PROPOSED AMENDED RECORD OF DECISION

SOUTH CAVALCADE STREET SUPERFUND SITE

October 17, 1996

FIGURE 2
CONCEPTUAL CAPPING DESIGN
SOUTHEAST AREA PLAN

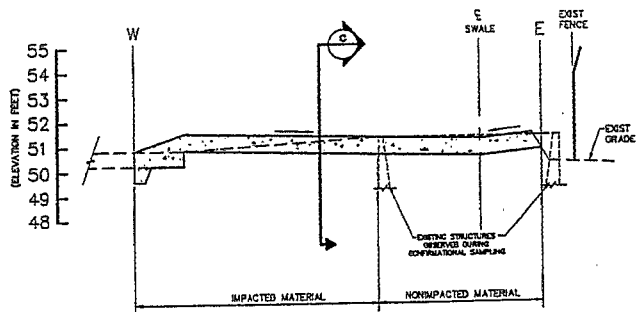
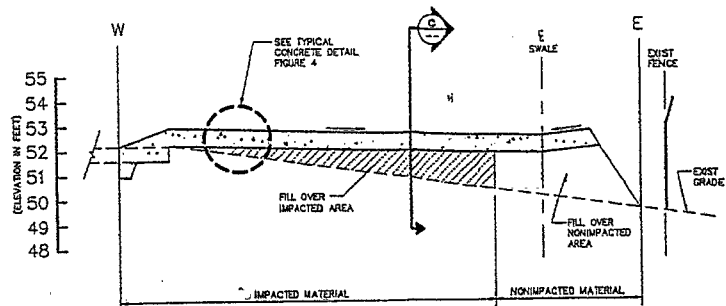
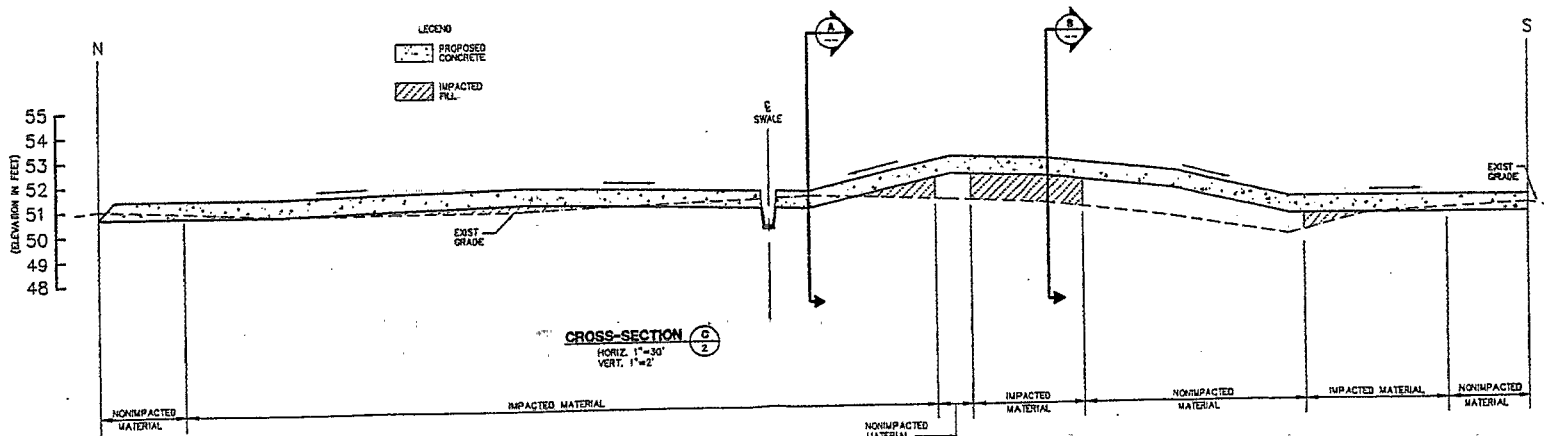
- Cross-Section A as shown in Figure 3 is a typical cut section. Impacted excavation from this area will be placed as fill material over other impacted zones. Cross-Section A is typical of approximately 20 percent of the Southeast Area.

- Cross-Section B as shown in Figure 3 is a typical fill section. Excavation of impacted or nonimpacted material is expected not to be required in the fill sections. Cross-Section B is typical of approximately 80 percent of the Southeast Area.

- Cross-Section C as shown in Figure 3 is cut through all the Southeast impacted zones. Inspection of this cross-section reveals the volume of fill within the impacted zones is greater than the expected volume of impacted excavation.

- The impacted soil excavated in the Northeast Area will be used as fill over the impacted zones of the Southeast Area.
- Provide Adequate Drainage
 - In the northern drainage area runoff from the existing westerly concrete pavement will be intercepted at the constructed ramp and directed to the north end of the cap or to a drainage swale formed into the cap as shown on Figure 2 and Cross-section C of Figure 3.

- In the northern drainage area the concrete cap will have a cross drainage slope to the east which will flow into a swale formed into the cap as shown on Cross-section A and B of Figure 3. The runoff from the northern end of the cap will be directed to an unpaved area in the northeast corner of Palletized and ultimately routed to the existing HB&T Railway ditch.

FIGURE 4
CONCEPTUAL CAPPING DESIGN
TYPICAL CONCRETE DETAIL

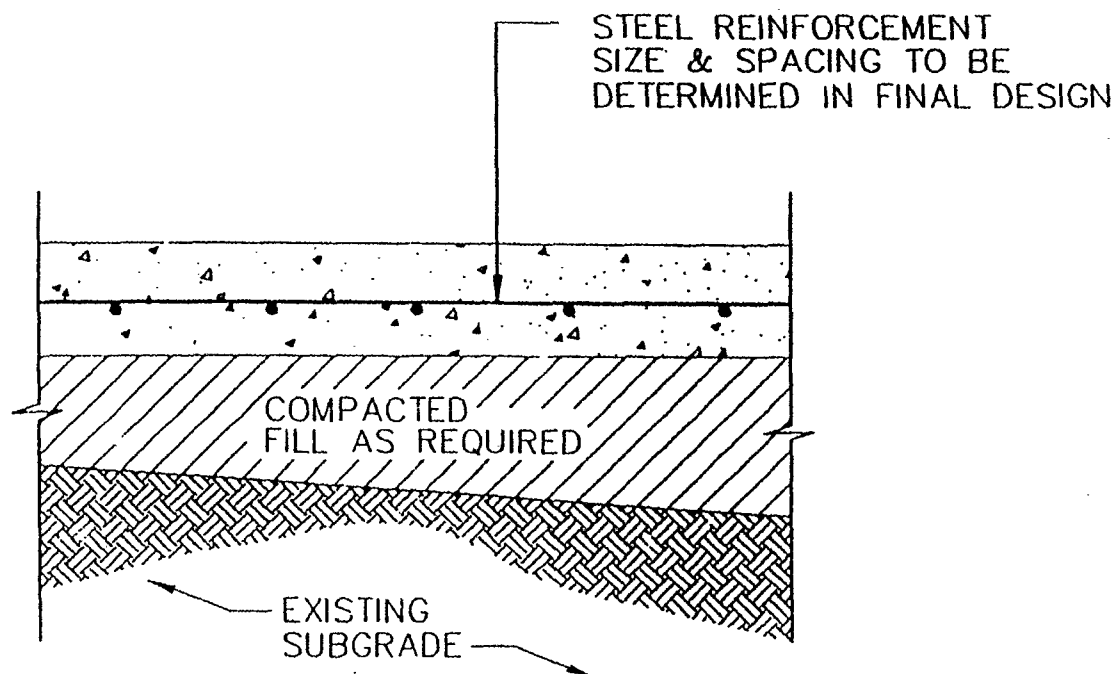
CONCRETE PAVEMENT
THICKNESS TO BE
DETERMINED IN FINAL
DESIGN, 6" MINIMUM

FIGURE 5
CONCEPTUAL CAPPING DESIGN
SO THEAST RAMP CLEARANCE

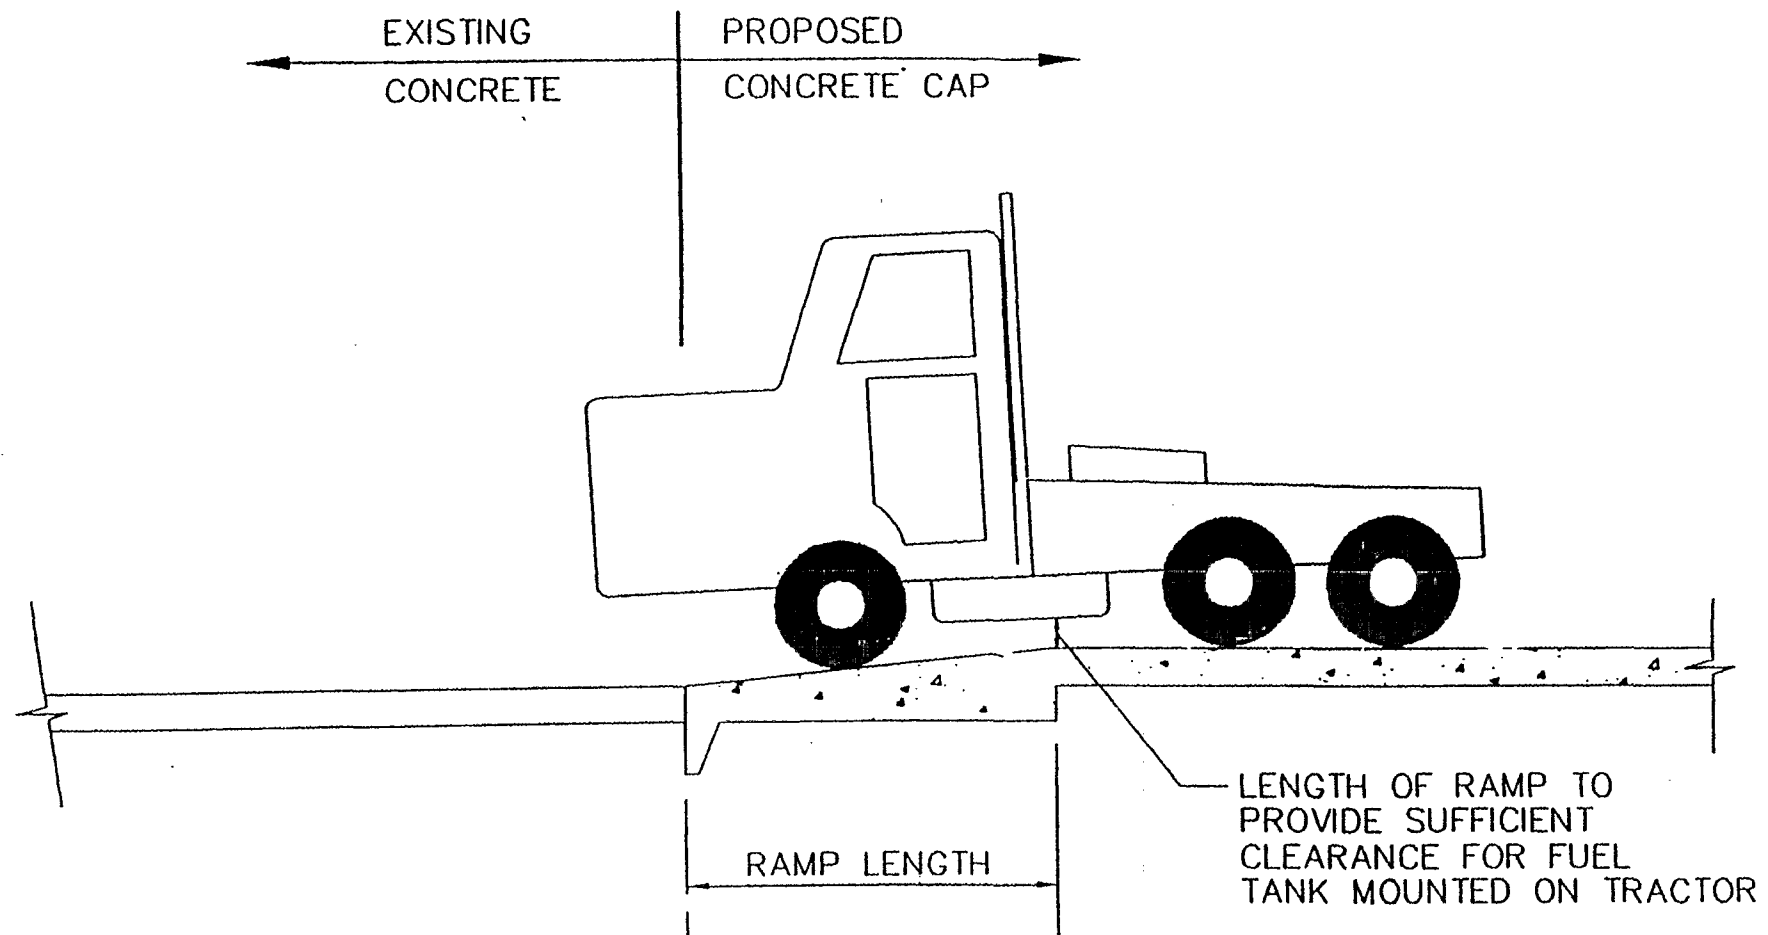
- Provide a Useable Concrete Cover
 - The slope of the concrete tarmac will be minimal to enable trailers to be parked.
 - Abrupt changes in grades will be avoided. Grade transitions will be achieved by utilizing ramps as shown in Figure 5.

- The slope of the concrete cap will be minimal to facilitate use as a vehicle parking area.
- Abrupt changes in grades will be avoided. Grade transitions will be achieved by utilizing ramps as shown in Figure 5. To access the top of the cap from the existing TPI driveway a ramp will be constructed as shown on Cross-Section D of Figure 7.
- The concrete cap will be of sufficient area to accommodate employee parking of private vehicles.
